MONROE PROPERTIES SUBDIVISION

APPLICATION NUMBER 13 DATE June 4, 2015

DETAIL SITE PLAN

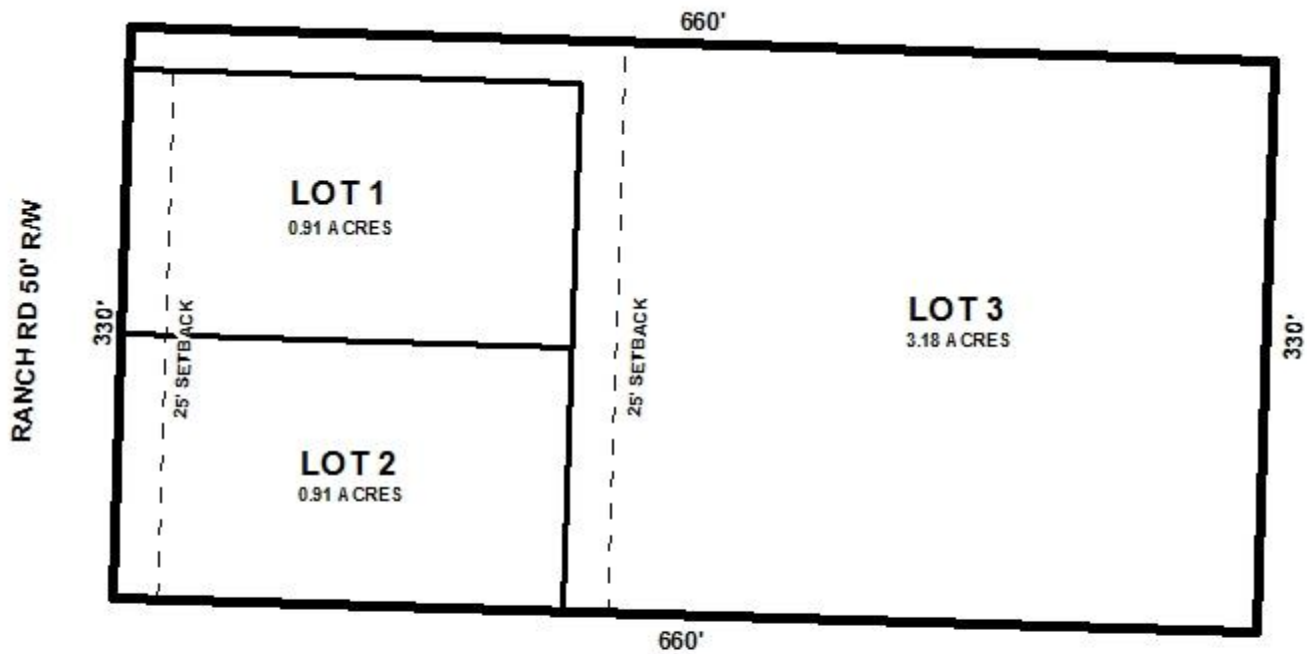
The site fronts on Ranch Road, a minor street with a 50' right-of-way; however, the street is unpaved and is not provided with curbs or gutters thus requiring a 60' right-of-way. The existing right-of-way depicted for the proposed subdivision is 50'; therefore dedication is required to provide 30' from the centerline. Additionally, as a means of access management, a note should be required on the Final Plat stating that each lot is limited to one curb cut each to Ranch Road, with the size, location and design to be approved by Mobile County Engineering and conform to AASHTO standards.

The plat indicates a 25' building setback line for all three lots and this should also be shown on the Final Plat. Each lot meets the minimum size requirements of the Subdivision Regulations and are labeled with their sizes in square feet and acres on the preliminary plat. If approved, this information should be retained on the Final Plat, or a table should be furnished on the Final Plat providing the same information.

The proposed Lot 3 would be a flag lot which is generally discouraged by Section V.D.1. of the Subdivision Regulations unless there are pre-existing barriers, or in the case of a family subdivision; neither of these exceptions appear to be applicable. Additionally, approving the request would increase the number of lots on an unpaved, sub-standard road. However if approved, a note should be required on the Final Plat stating that no further re-subdivision of Lot 3 will be allowed until additional public street frontage is provided.

Based on the preceding, the application is recommended for Denial due to the following:

- 1) no justification of request for approval of a flag lot based upon criteria of Section V.D.1. of the Subdivision Regulations; and
- 2) request would increase number of lots on an unpaved, sub-standard road.
